# City of Ukiah, CA Design Review Board

## MINUTES

November 13, 2014

6A. **Grace Hudson Nature Education Project Site Development Permit, 531 South Main Street (File No.: 569):** Review and recommendation to Planning Commission on a Site Development Permit for the Grace Hudson Nature Education Project, 531 South Main Street, APNs 002-281-26 and 002-281-31.

## Grace Hudson Nature Education Project Design Review | Nov. 2014

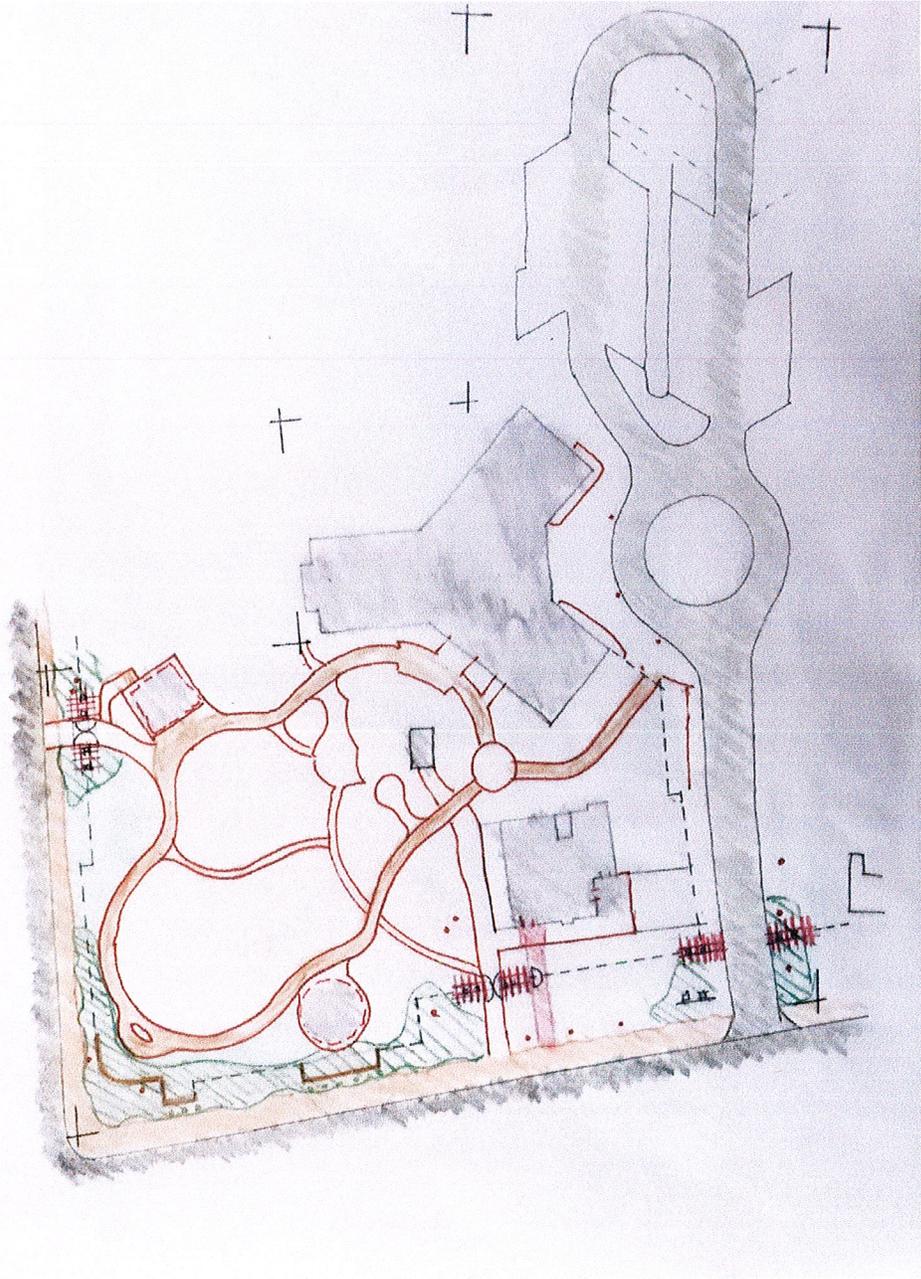
I am concerned with the urban boundary and the aesthetic meaning or symbolism expressed in the surrounding fencing, walls and entry's.

Part of the enduring relevance of the Hudson home is that it presents itself with an open doorstep and welcoming spirit of inclusion. There is currently an unmistakable lack of consideration for the public entrance. There is neither a reference for pedestrians nor vehicle traffic announcing a welcoming element in the entry procession., but merely a hole in the perimeter fence to find your way to the back door and museum.

I would propose consideration of pulling the perimeter fencing into and integrating it as part of the landscape instead of a surrounding security barrier to the public. This way the garden becomes part of the urban experience and softens the .

The second consideration would be to use some of the greatly admired design vocabulary existing in the Hudson grounds for inspiration in creating an appropriate and welcoming entry. Perhaps trellis's in the spirit of the existing arts and crafts expression or something more contemporary but with the inherent symbolism. This could include signage, lighting and the mail box apparently in use.
